Our Oct. 17 summary described four issues with the Crone data. These are listed below in order of importance, along with our response to Crone's comments on the issues.

Figure 1: Comparison of data at 5000N on Line 5400E (Loop A) following timing correction and adjustment of axial coil amplitude by 25%. This is a modification of the figure on Page 2 of crone_data_issues_edit.pptx.

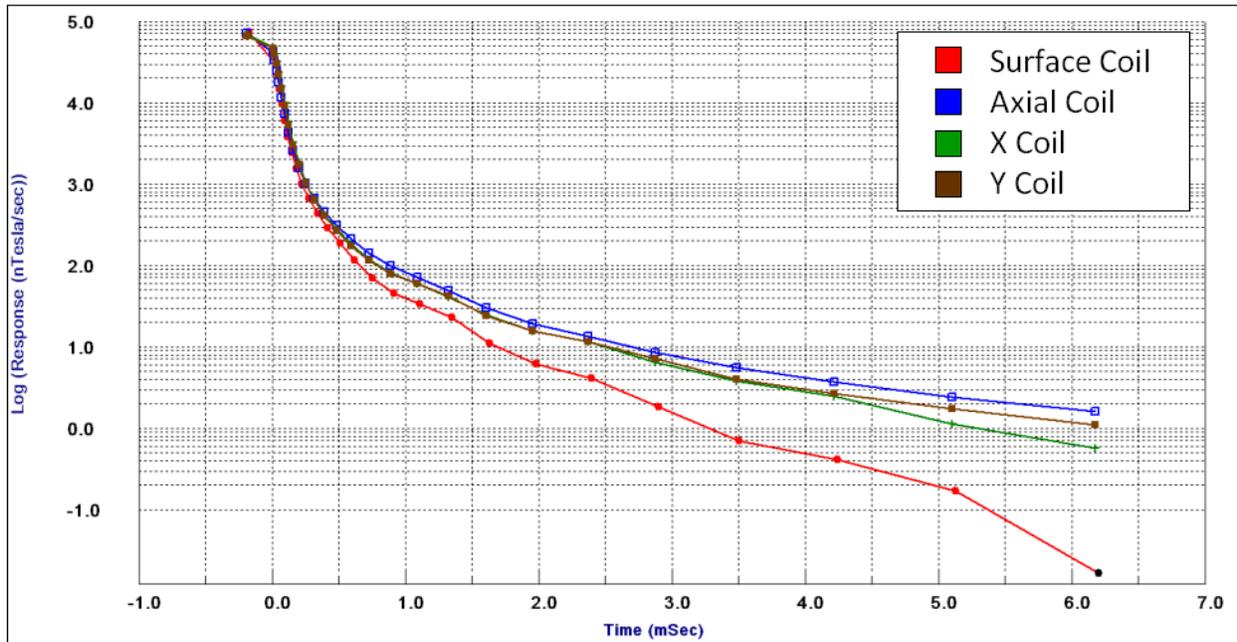
a) Axial vs. Surface Coils

Crone acknowledges that there are "slight" differences between the axial and surface coil decays inside the loop after accounting for timing differences. However, we do not consider these differences to be slight in any way! (See Figure 1.) The axial data have much slower decays at mid-late times; they indicate a conductor at depth whereas the surface data do not.
